TO: Mayor Pugh and the Village Board of Trustees  
FROM: Chairman Luntz, Planning Board  
DATE: December 31, 2020  
RE: Hudson National Golf Club Solar Matrix Project-- Special Permit Recommendation

At its regularly scheduled meetings on October 27, November 10, December 8 and December 22, 2020, the Village of Croton-on-Hudson Planning Board reviewed the Village Board referral of the application for a Special Use Permit for Hudson National Golf Club Solar Matrix project at 40 Arrowcrest Drive.

## Resident Comments Re: Hudson National Matrix Solar Array Project

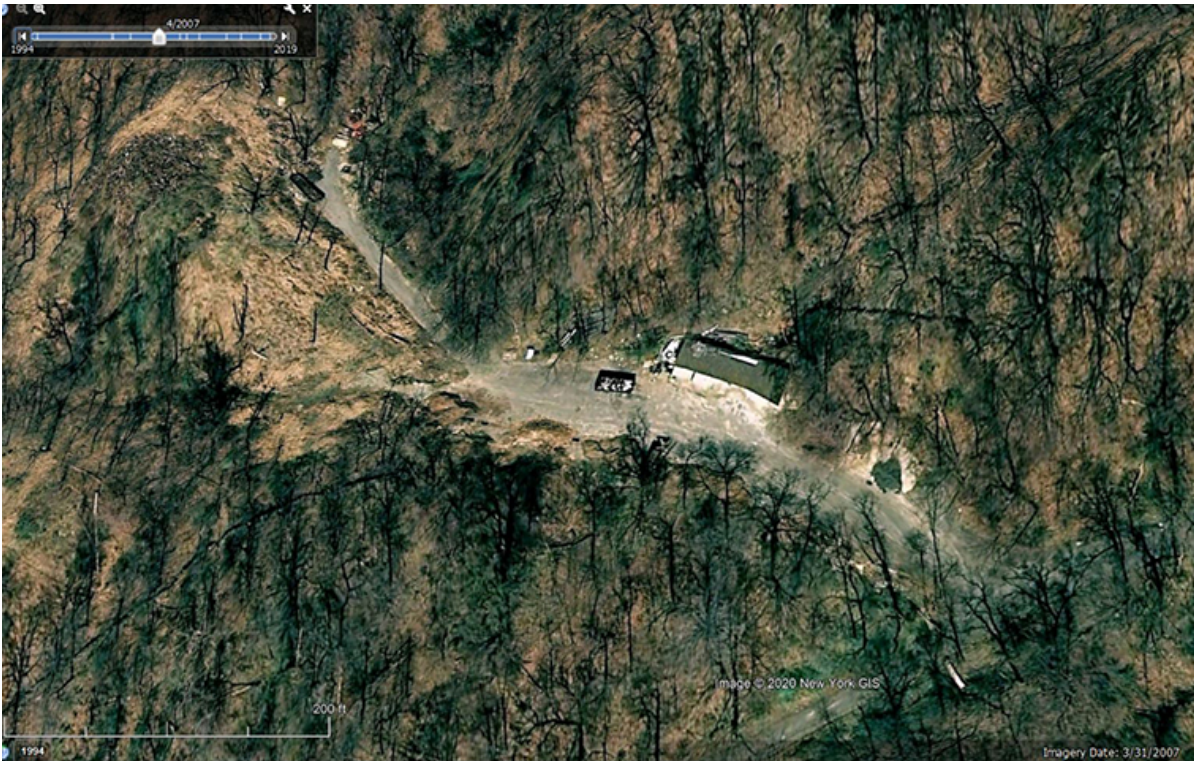
Upon seeing the erosion control plans for the proposed solar fields using the "existing" drainage course as a suitable solution, my neighbors and I were deeply concerned. Our position is:

1. The "existing" drainage course was apparently established illegally without review, permit, or professional engineering. It is significantly overburdened during a storm; under storm conditions runoff water causes damage to our properties.
2. Adding more water to this "existing" situation without proper re-engineering and installation of functional storm water runoff controls meeting code and best practices should not be permitted. The original EIF submitted to the board for the Solar project, misrepresents this condition.
3. The existing situation needs to be remedied whether or not the Solar Electric project is permitted.

Dan, I believe you and I agreed that the storm water runoff plans the Hudson National consulting engineer completes must address these existing run off problems, as well as the additional burden the solar fields construction and maintenance roads would add. I firmly asked that 50- and 100-year storm calculations be applied.
